**Evaluation tightening
preloaded bolt assemblies according to
EN 1090-2
“Technical requirements for steel structures”
for 95% reliability EN 1990 ***

Produced for CEN/TC 135 WG2

***This evaluation is accepted by CEN/TC 135 WG2 in their meeting September 10, 2012
to use for the next revision of the EN 1090-2 “Technical requirements for steel structures”.**

**Purpose of this document is to evaluate the results of
chapter 8.5 “Tightening of preloaded bolt assemblies”
EN 1090-2 Execution of steel structures and aluminium structures
Part 2: Technical requirements for steel structures.**

Figure D.1

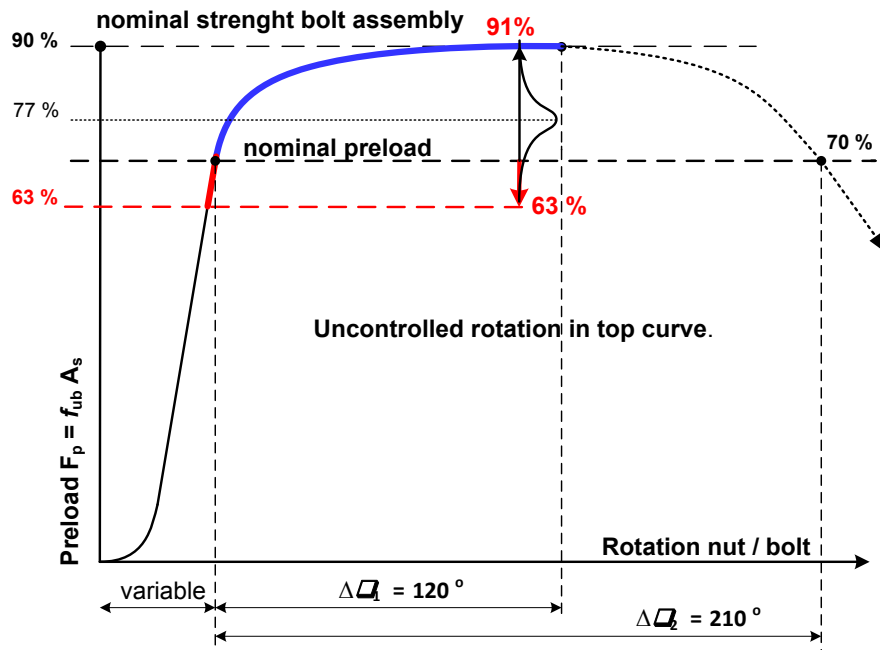
The k -factor $V_k \leq 0,10$ with a target mean value of $0,77 f_{ub}A_s$ is too wide to match the preload of $0,70 f_{ub}A_s$ asked for in the design codes and therefore leads to an unacceptable reliability of 79,4 % instead of the required 95 %. (last line Annex D.1.1 column 2 and Figure D.1)

Figure D.2

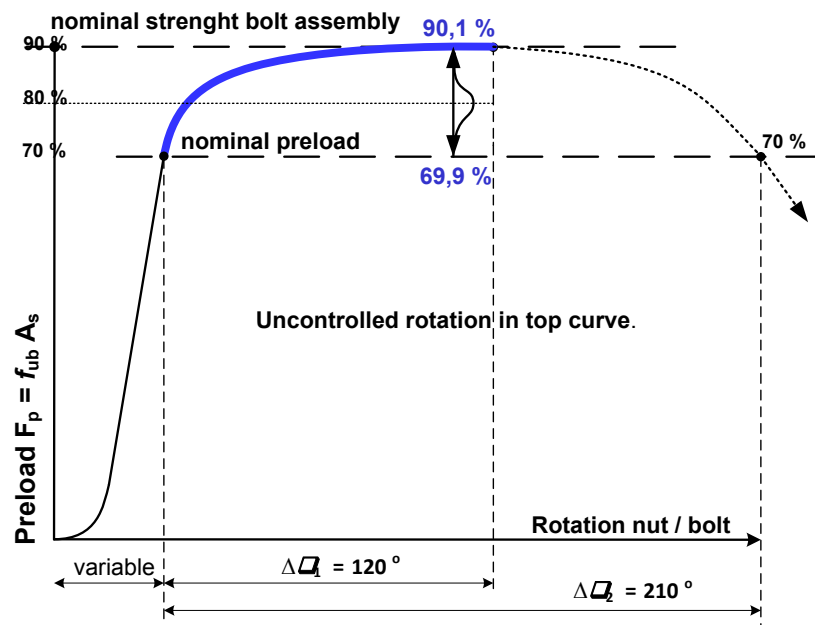
1. To reach the 95% asks for $V_k \leq 0,06$ in the EN 1090-2 with a connecting mean target value of $0,80 f_{ub}A_s$ instead of $0,77 f_{ub}A_s$.

This adjustment will rise the reliability up to 94,8 % (Annex D.1.2 column 3, Figure D.2)

The Figures D.2 and D.3 show clearly that most of the bolts shall yield using the Torque method, some to the same level as tightened by the Combined method, but uncontrolled.

Figure D.4

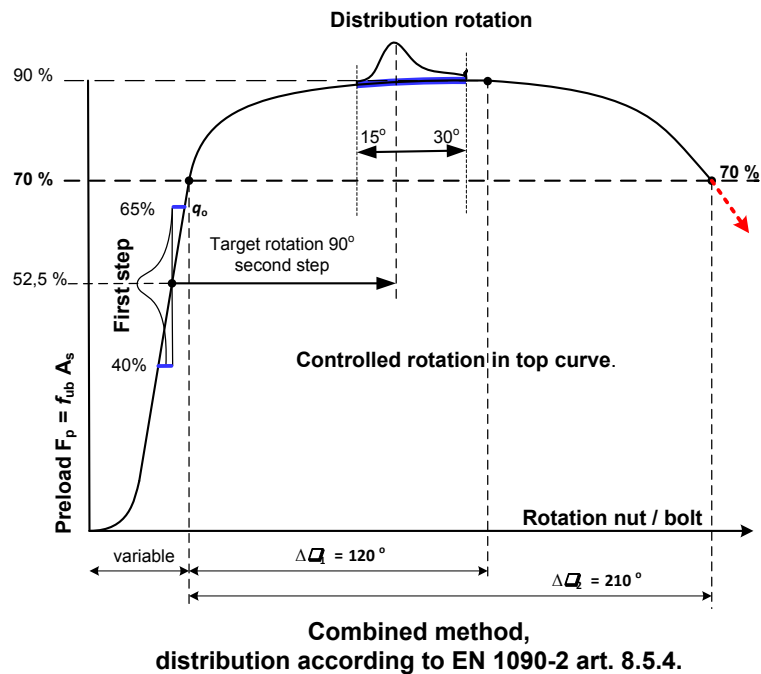
The reliability to reach $0,70 f_{ub}A_s$ is 100%. Moreover, the expected preload is close to the real $0,90 f_{ub}A_s$ yield strength of the bolt assembly. This additional preload, above the demanded $0,70 f_{ub}A_s$, gives an extra security for losses due to eventual creep due to layers of corrosion protection in the connections, or for the resist to structural loads on the connections. (See Figure D.4)

This simplification may in extreme lead to a bottom preload of $0,10/0,13 \times 0,525 f_{ub}A_s = 0,40 f_{ub}A_s$ and a top value of $0,16/0,13 \times 0,525 f_{ub}A_s = 0,65 f_{ub}A_s$. This will create a small difference in the rotation on the steep elastic part of the rotation/preload curve. (δ_o in figure D.4)

Figure D.5

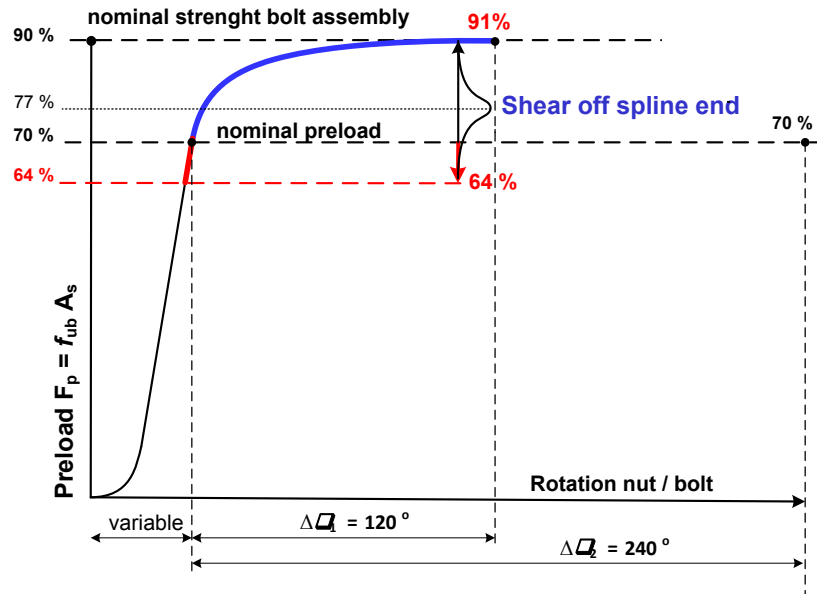
The k -factor $V_k \leq 0,10$ is too wide to match the preload of $0,70 f_{ub}A_s$ asked for in the design codes and leads to an unacceptable reliability of 81 % instead of the required 95 %.
(Annex D.2.1 column 2, Figure D.5)

Figure D.7

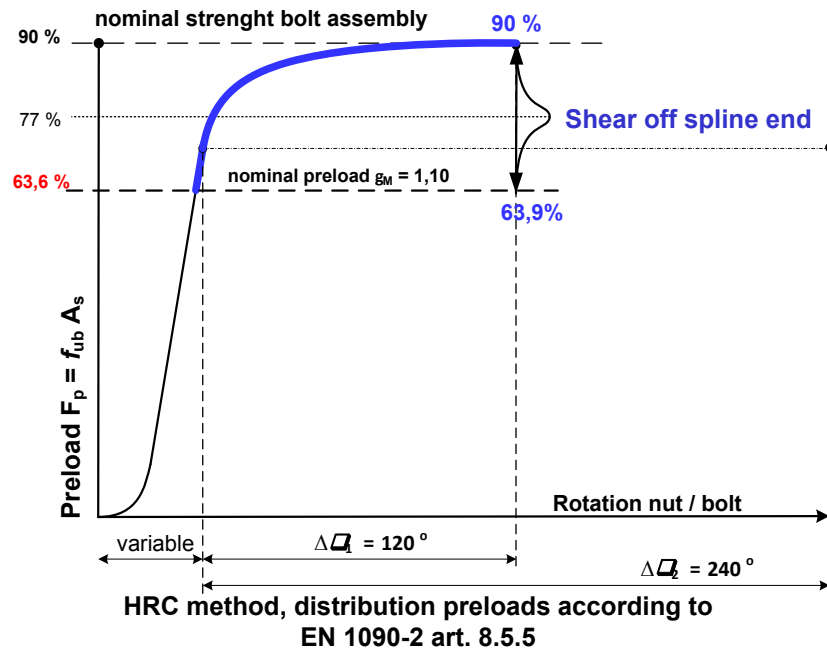
1. To meet 95% reliability, requires that $V_k \leq 0,06$ should be demanded in the EN 1090-2 with a mean target value of $0,79 f_{ub}A_s$ instead of $0,77 f_{ub}A_s$. This adjustment will raise the reliability up to 95,9 % (Annex D.2.2 column 3, and Figure 6). This may also be changed in EN 14399-10.
2. A second solution should be the introduction of an extra reduction factor for the HRC method $\gamma_{torque} = 1.10$ too on the value of the nominal preload for design in the EN 1993 design codes. This adjustment will raise the reliability up to 95,4% (Annex D.2.3 column 3, and Figure D.7).
